GREEN ARROW SWEATER IND.LTD

68/69, South Shampur, Hemayetpur, Savar, Dhaka.

25 August 2025

FOOTINGS LAY-OUT PLAN
SCALE: 1/100

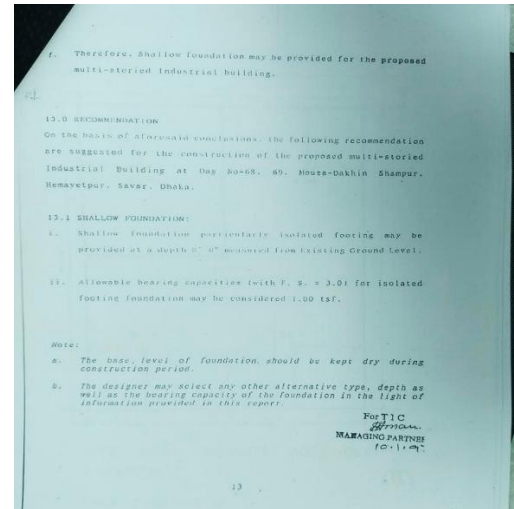
Observation-01: High Stress in column and foundation. (Production Building)

Description: Cursory calculation indicates the internal footings and columns under the toilet zone are highly stressed for allowable bearing capacity and minimum concrete strength of brick aggregate. We considered the observed live load 2 kPa for typical floor. Also, the ultimate bearing capacity of the soil was considered 2 ksf, as per the soil test report.

The building engineer is required to commence a Detailed Engineering Assessment (DEA) to which required immediate review of the design, load and foundation & column stresses.

Item No	Observation	Action Plan	Timeline
1.	High Stress in column and foundation. (Production Building)	The factory must engage an expert structural and geotechnical consultant to prepare accurate as-built drawings, verify foundation size and thickness, conduct a Detailed Engineering Assessment (DEA), perform material testing (concrete and rebar), and carry out a geotechnical investigation.	Immediate

2.	High Stress in column and foundation. (Production Building)	Verify in-situ test from each class of concrete at least 4 nos. (column, beam & slab).	Immediate

3.	High Stress in column and foundation. (Production Building)	The building engineer is required to carry out Detail Engineering Assessment (DEA) to review the design, load and foundation stresses.	within 6 weeks

4.	High Stress in column and foundation. (Production Building)	Verify rebar tensile strength and incorporate the value in DEA.	within 6 weeks
5.	High Stress in column and foundation. (Production Building)	Produce and actively manage a loading plan for all floor plates within the factory, considering floor, column, and foundation capacity.	within 6 weeks

Observation-02: Concrete condition assessment. (Production Building)

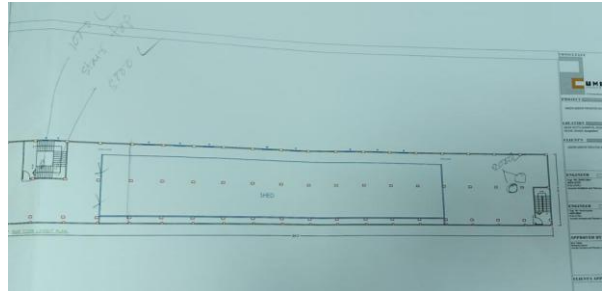
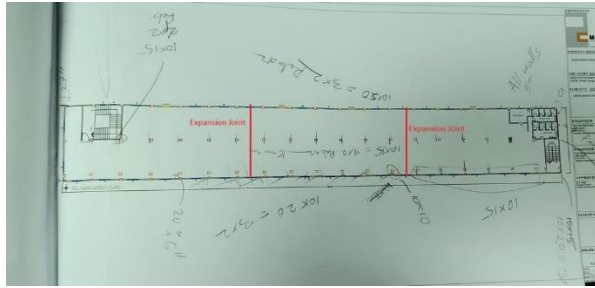
Description: During the preliminary visual inspection, it is apparent that the condition of the concrete structure is deteriorating. Some of the key signs of concrete deterioration include cracking, discolouration, leaks, damp patches. In these cases, further tests required to be of use to the Engineer in diagnosing the cause of deterioration and therefore in designing a method to prevent it from compromising the adequacy of the structure.

It is recommended that a qualified structural engineer conduct a thorough visual inspection of each floor to identify key signs of concrete deterioration, including cracking, spalling, discoloration, leaks, damp patches, reinforcement corrosion, and evidence of previous repairs. All findings should be photographed, mapped, and recorded.

Where deterioration is observed, further investigations shall be carried out using appropriate non-destructive and destructive testing methods, including:

- Full delamination (hammer tap) survey in accordance with ASTM D4580-23.
- Cover survey to confirm reinforcement depth.
- Ultrasonic pulse velocity (UPV) testing to identify voids or cracks.
- Half-cell potential survey in accordance with ASTM C-876-22b.
- Carbonation depth measurement.
- Chloride profile testing where necessary.

The results of these investigations should be used to determine the extent, cause, and severity of deterioration, thereby providing appropriate repair and remediation strategies.
